# Access Compliance Report

## Public Rights-of-Way

### (Curb Ramps)

Intersection ID: 2855	Main Street: SWANSTON_DR	Cross Street: TORPHIN_CT	Location: SE
ADA ID: 2F6C8281FE5C	Ramp Type: PerpDiag	Initial Pass/Fail: Fail	Overall Compliance: No
		Severity Score: 1.25

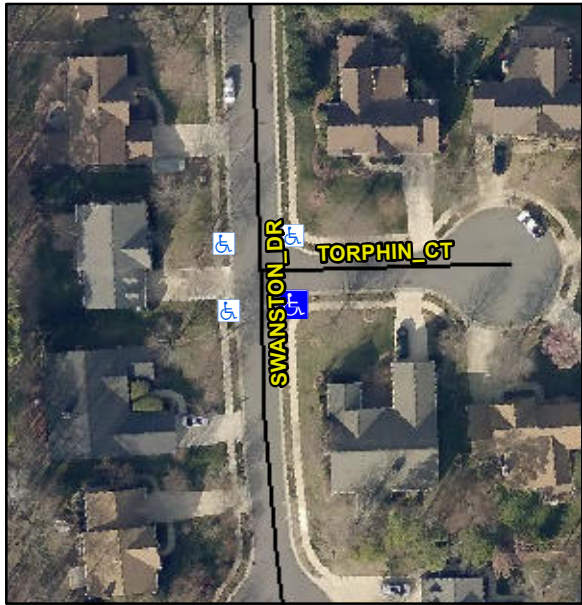
Codes/Mitigation Info/Possible Solution			Field Measurements/Component Compliance					
	Possible Solutions:		Compliance	Description	Data	Compliance	Description	Data
	Remove & Replace Curb Ramp With Two New Directional Ramps or Equivalent.		N/A	Ramp Length (in)	49.0	Yes	Ramp Slope (%)	6.3
			Yes	Ramp Width (in)	60.0	No	Ramp XSlope (%)	2.9
			N/A	Flare Type LT	N/A	N/A	Flare Type RT	N/A
			N/A	Flare Slope LT (%)	N/A	N/A	Flare Slope RT (%)	N/A
			N/A	Flare Traversable LT?	N/A	N/A	Flare Traversable RT?	N/A
			N/A	Landing Length (in)	N/A	N/A	DWS Provided?	N/A
			N/A	Landing Width (in)	N/A	N/A	DWS Contrast?	N/A
			N/A	Landing Slope (%)	N/A	N/A	DWS Length (in)	N/A
			N/A	Landing X Slope (%)	N/A	N/A	DWS Full Width?	N/A
Street 1 Name Stop Condition-Street 2 Street 2 Name Stop Condition-Street 1	TORPHIN CT StopSign SWANSTON DR None		N/A	Landing Curb? (Y/N)	N/A	N/A	DWS Offset (in)	N/A
			N/A	Shared Landing?	N/A

N/A	Gutter Ponding?	N/A	N/A	Gutter Slope (%)	N/A
			N/A	Gutter Lip Ht (in)	2.0	N/A	Gutter X Slope (%)	N/A
			N/A	Painted X Walk1?	No	N/A	Painted X Walk2?	No
				X Walk 1 Direction	To N		X Walk 2 Direction	To W
			N/A	X Walk 1 Width (in)	N/A	N/A	X Walk 2 Width (in)	N/A
				X Walk 1 Slope (%)	0.9		X Walk 2 Slope (%)	2.9
				X Walk 1 X Slope (%)	2.9		X Walk 2 X Slope (%)	2.0
			N/A	Ramp inside XWalk1?	N/A	N/A	Ramp inside XWalk2?	N/A
			Road Slope (%)	0.9	N/A	Clear Space?	N/A	
			Road X Slope (%)	7.0	N/A	Clear Space to XWalk (in)	N/A	
		N/A	Any Obstructions?	N/A	N/A	Storm Grate/Utility Hazard?	N/A	
			Obstruction Type			Storm Grate/Utility Type		
					N/A		N/A	
					Yes	Surface Condition? (G/P)	Good	
Total Cost:		\$ 3200.00
